**SECTION 16 APPLICATION
TOWN PLANNING ORDINANCE (CHAPTER 131)**

Town Planning Application No. A/YL-NSW/349 - Submission of Further Information (1)

Response-to-Comment Table

**LOCATION OF REPRESENTATIVE AIR
SENSITIVE RECEIVERS**

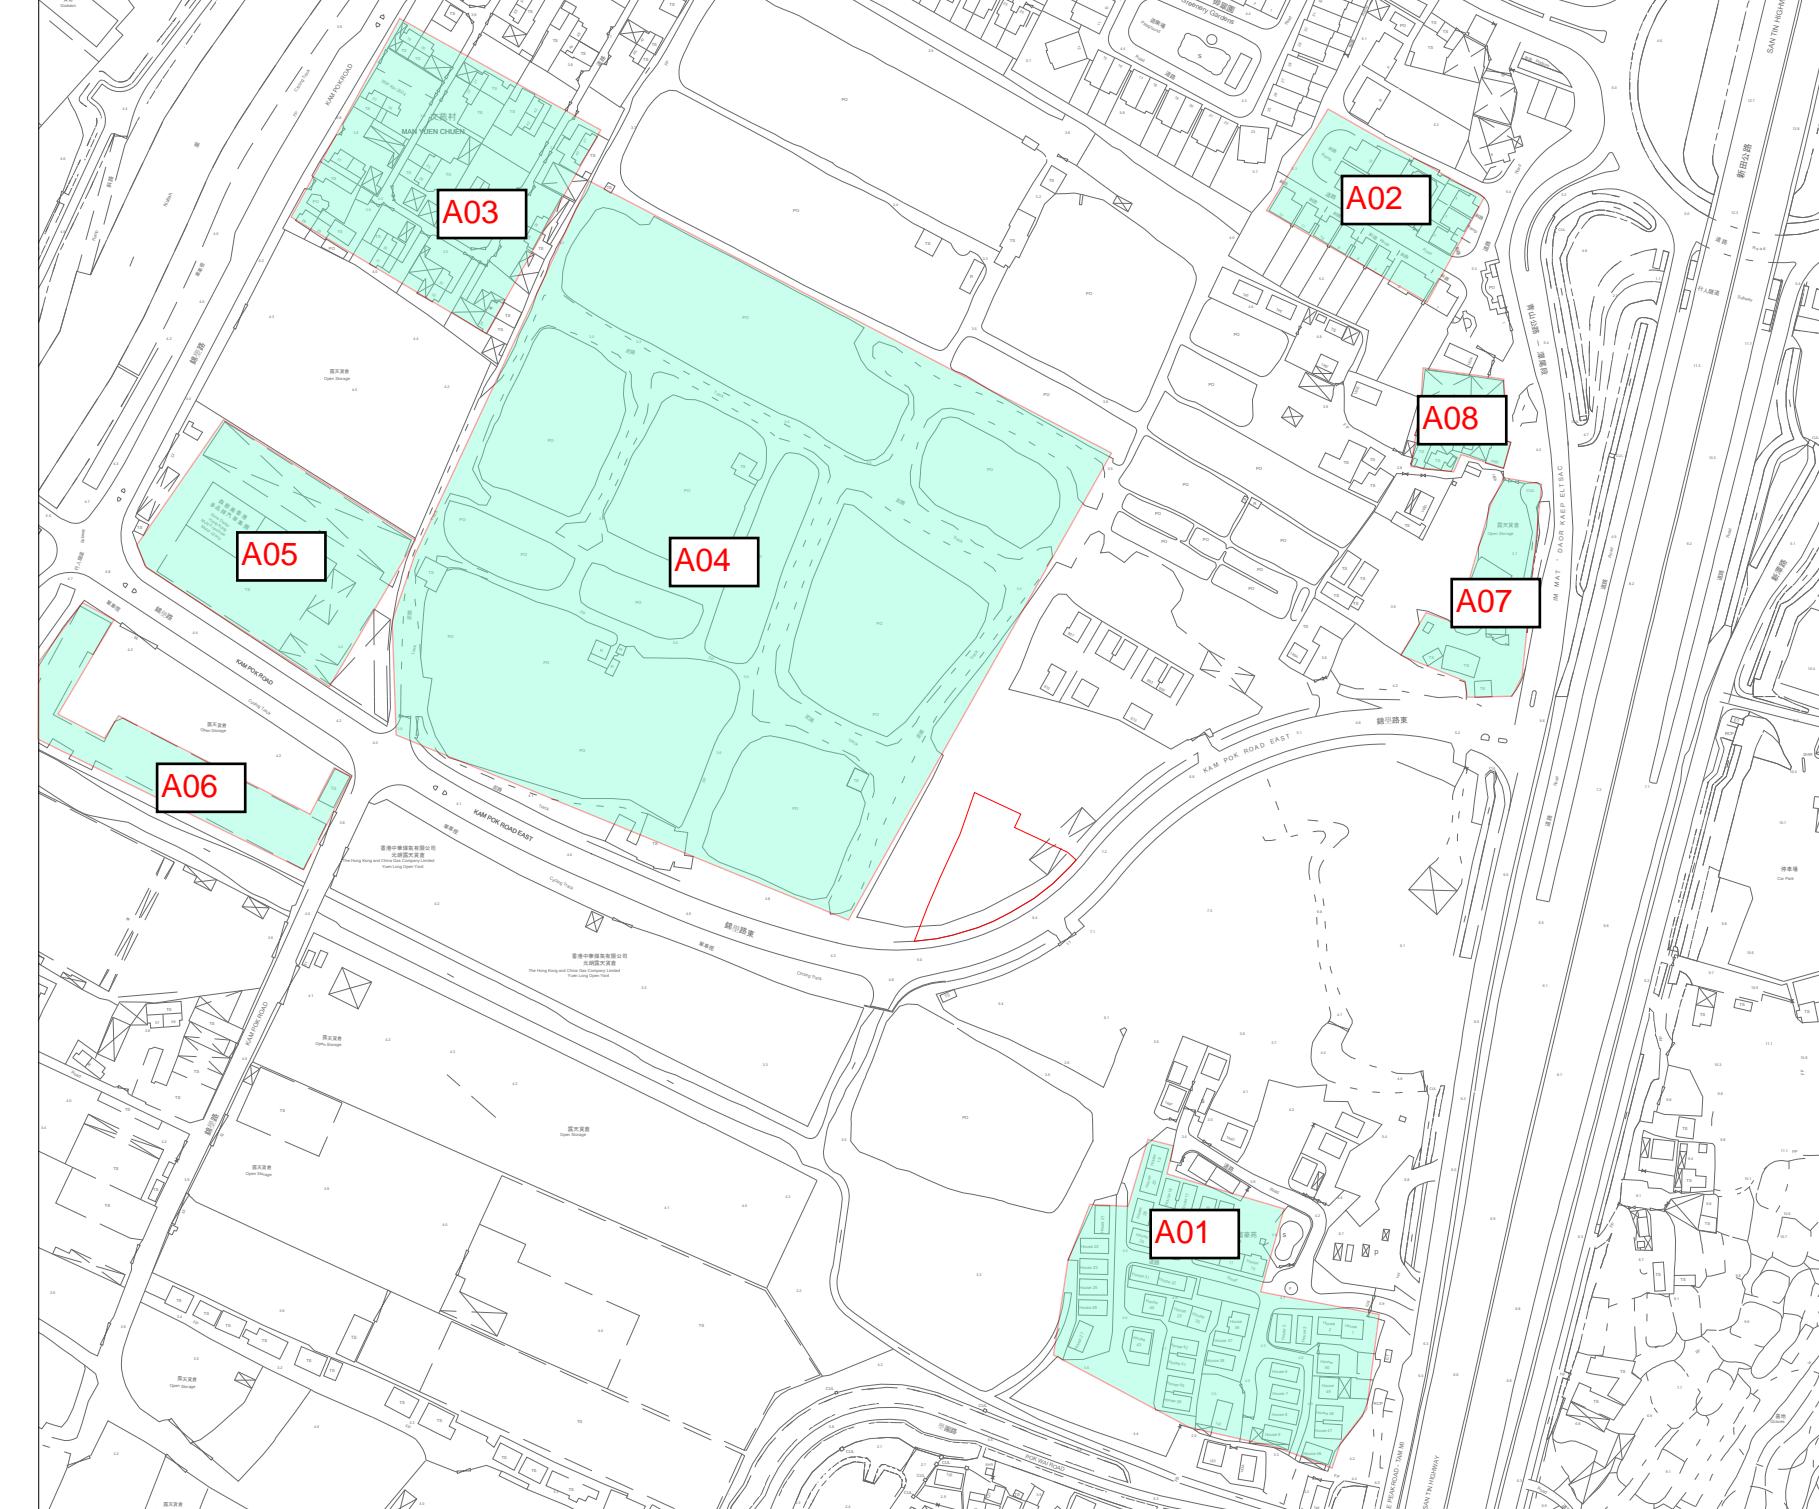
3. Section 2.3.1, Table 2.3 and Figure 2.1 - Please note that not only the domestic premises are the ASRs, some places/premises such as factory and workshop may also be the ASRs. Based on the desktop review, there are some areas in the vicinity of the project site which have been used for workshops/open storage, etc. Please review the potential existing/planned ASRs within the assessment area with reference to the Determination of ASR under the EIAO-TM and update as appropriate.	More ASRs have been identified in Table 2.3 and Figure 2.1. For other areas mainly for open storage use where long duration of exposure to air pollutants is not expected are, therefore, not considered as ASR.

**FIGURE 2.2
BUFFER DISTANCES**

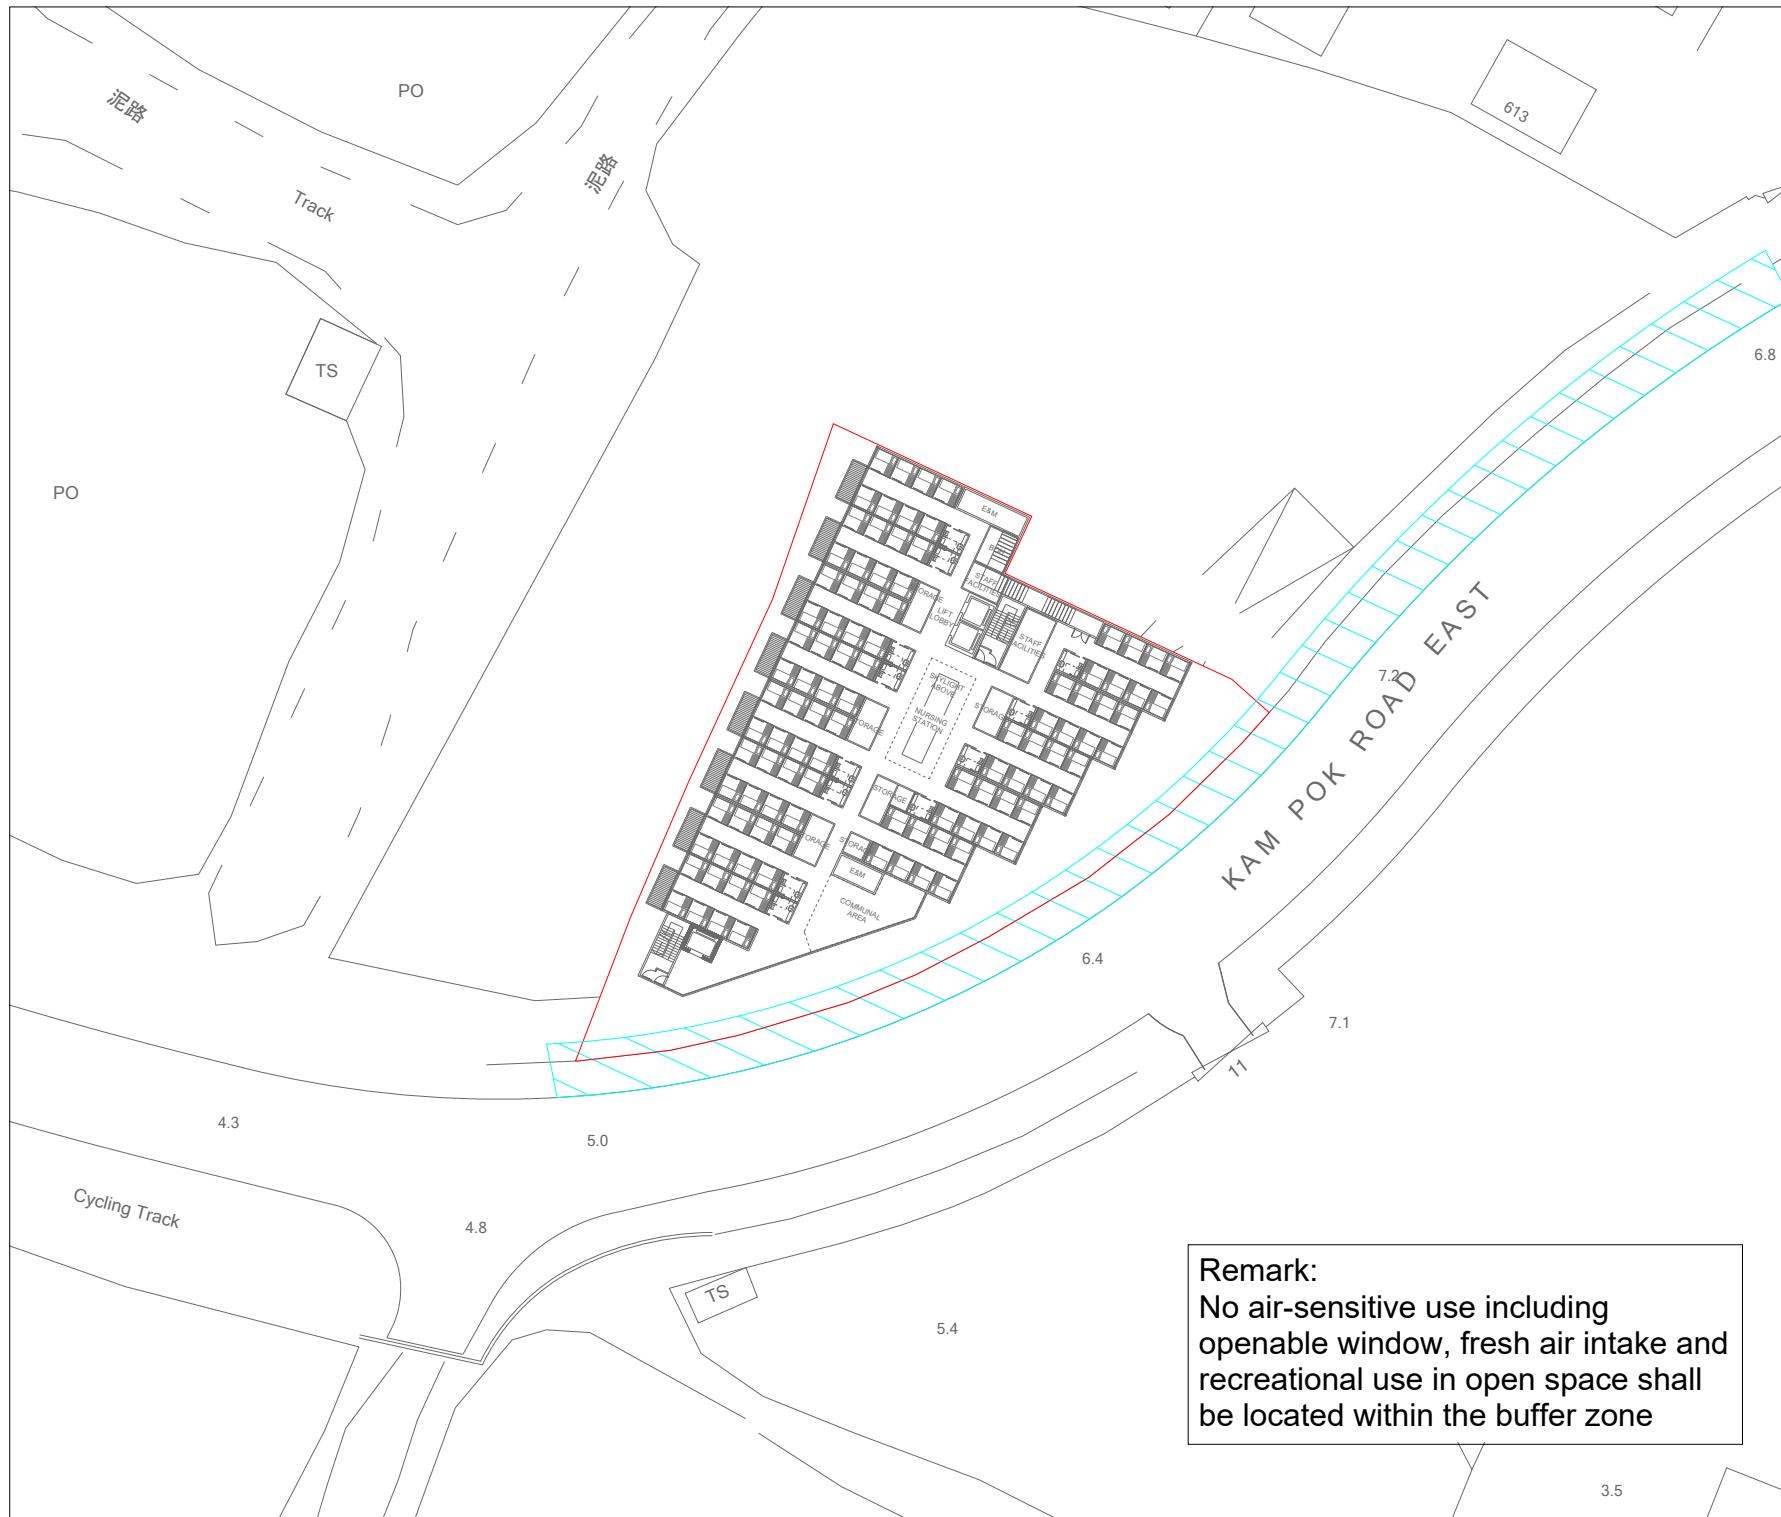
<p>12. Figure 2.2</p> <ul style="list-style-type: none"> a. The buffer distance should be measured from the edge of road kerb. Please update and present the buffer zone appropriately. b. Please show the road name of Kam Pok Road East clearly in the figure. c. Please add a remark "No air-sensitive use including openable window, fresh air intake and recreational use in open space shall be located within the buffer zone". 	<p>Figure 2.2 is revised accordingly.</p>
---	---

EXISTING SEWERAGE SYSTEM

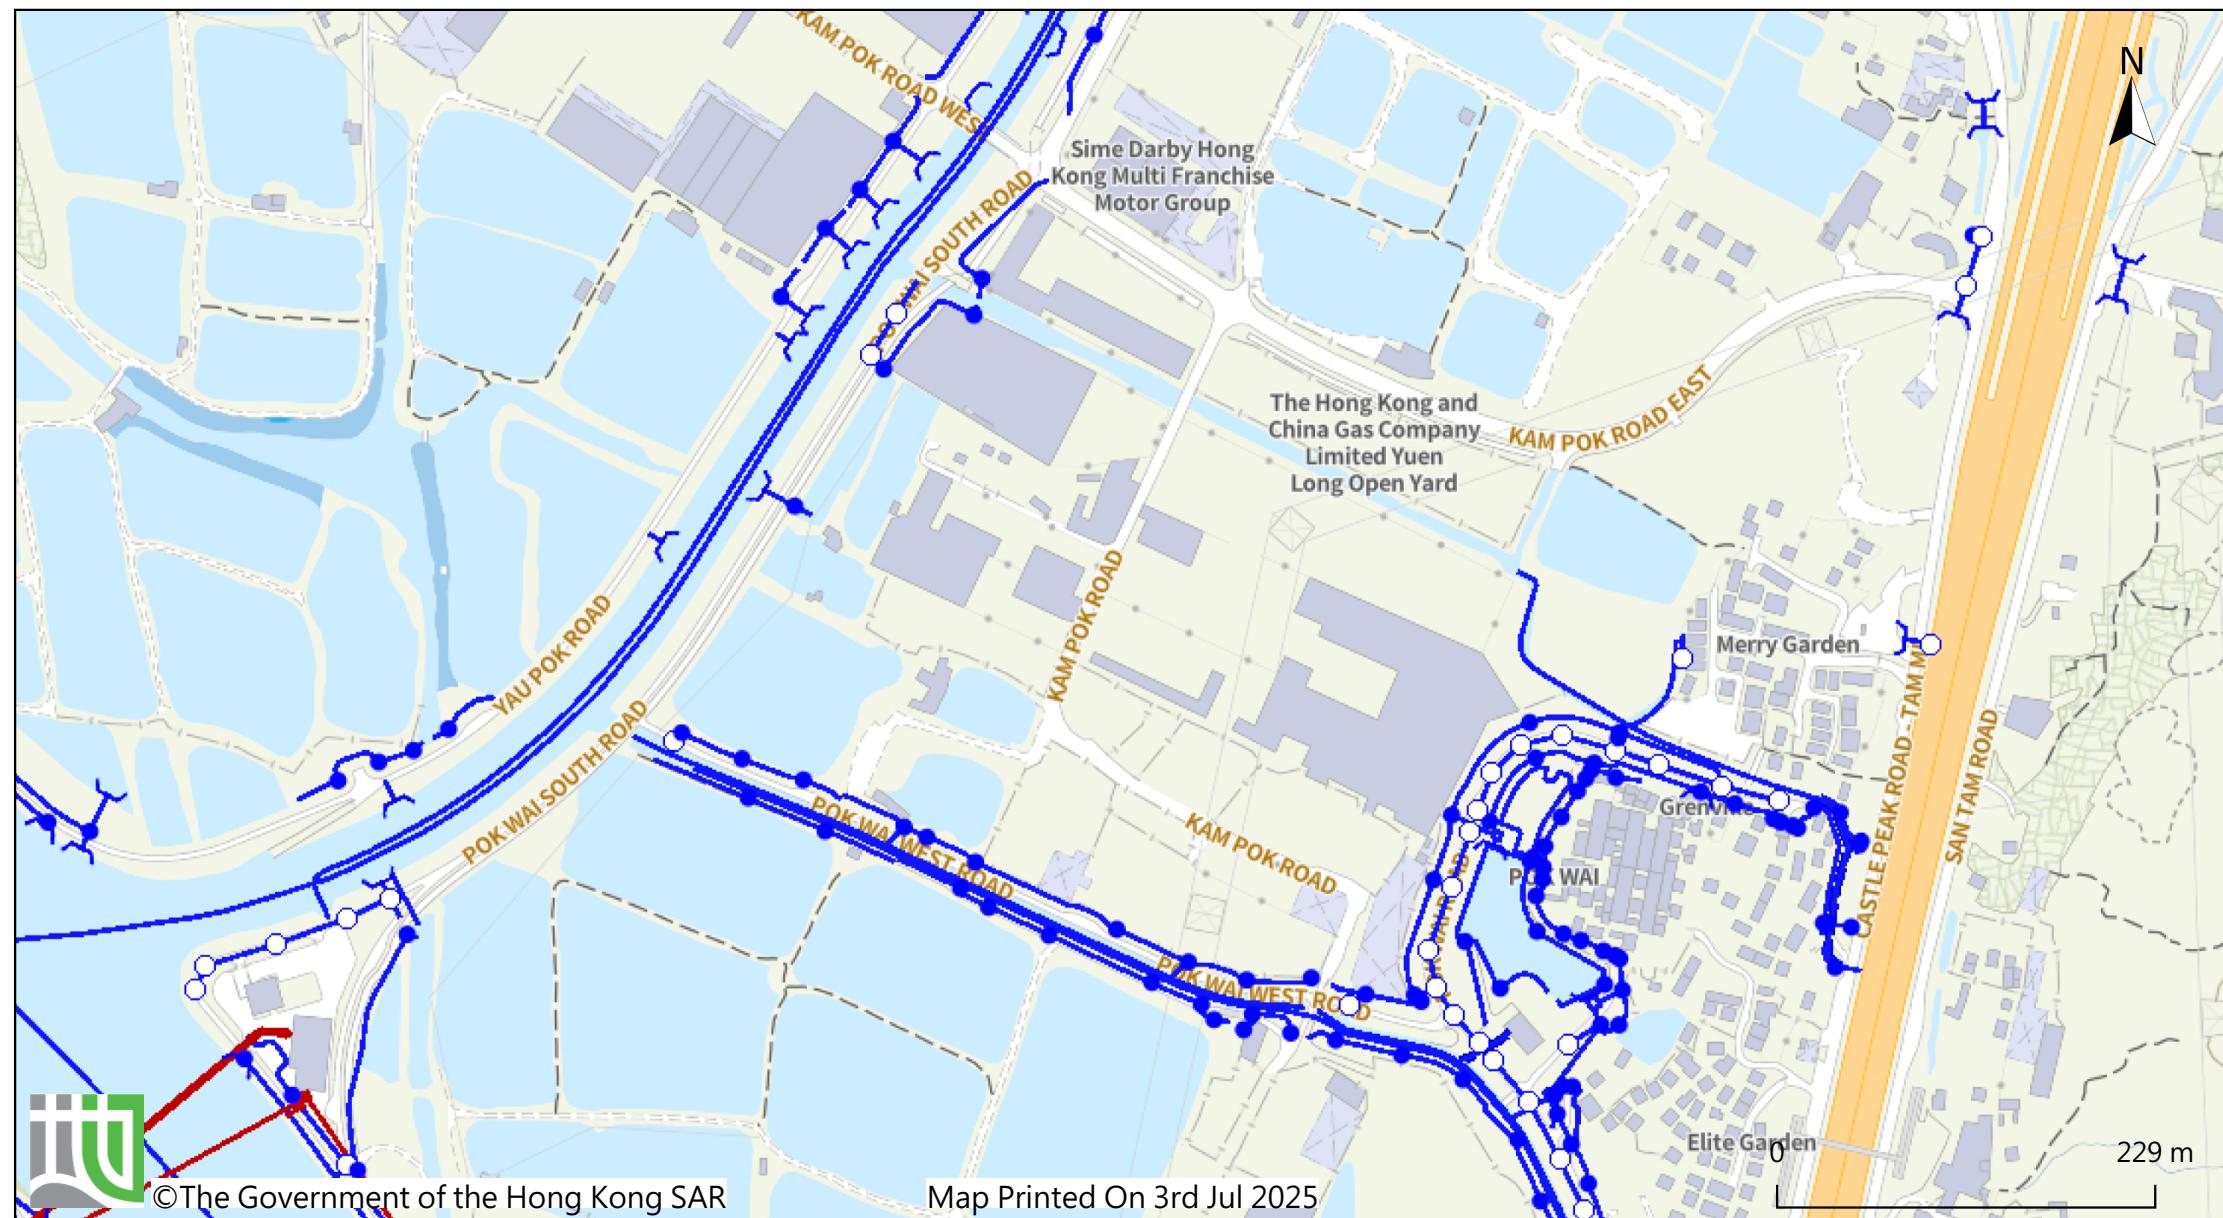
<p>1. Para. 2.2.1 - Please check if the Figure 2 including existing sewerage record;</p>	<p>Figure 2 is supplemented.</p>
<p>2. Para. 2.2.2 - Please review "coube";</p>	<p>The typo is revised.</p>
<p>3. Para. 2.2.2 - Please review "termination" should read "terminal";</p>	<p>The typo is revised.</p>
<p>4. Para. 3.1.2 - Please clearly show the existing sewerage system on drawings for reference;</p>	<p>The existing sewerage system is indicated in Figure 3.</p>
<p>5. Please advise who will implement and maintain the proposed sewerage system/facilities. Please discuss in the report text and prepare a drawing for comment; and</p>	<p>Figure 3 is updated to include liability of implementation and maintenance. Detailed discussion refer to Para 2.2.2 and 2.2.3.</p>
<p>6. Figure 3 - Please indicate all cover levels. Please note that the cover level(s) of terminal manhole(s) should be higher than that of the downstream public manhole(s). Please include the above in report text and drawing remark.</p>	<p>The cover levels has included in Figure 3. Report text is provided in Para.2.2.3.</p>
